BUCKINGHAM TOWN COUNCIL

15/02953/APP – Hamilton’s Precision site, Tingewick Road

Demolition of existing Class B2 warehouse and construction of 54 dwellings with access and associated parking (amendment to planning application 14/03450/APP currently under appeal status.

Overview:

Fig 5 Initial scheme looking at the flood plan and the need for the development to not encroach the flood zone. This shows an example of what should be avoided.

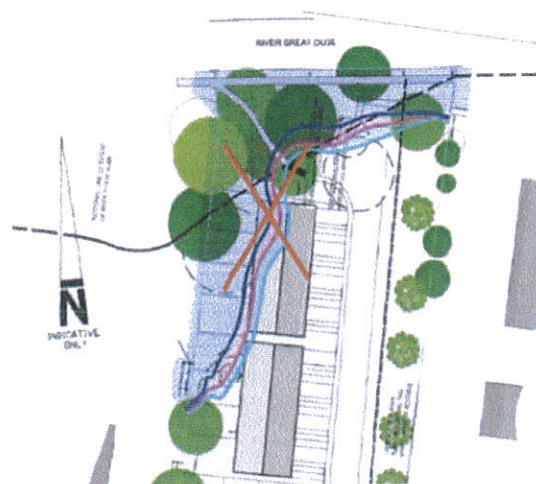
(p25) Members might like to compare “what should be avoided” with the layout plan attached:

5.9 FLOODING AND DRAINAGE

5.9.1. The northern portion of the site extending approximately 53m from the river's edge, is identified as being within the 1 in 100 year flood plain. Development should not encroach on this part of the site. It is intended to make any part of this site open land or dedicate this portion as public amenity space.

5.9.2. The need for pumping of foul drainage to existing sewers into Tingewick Road should be recognised in the layout of the site.
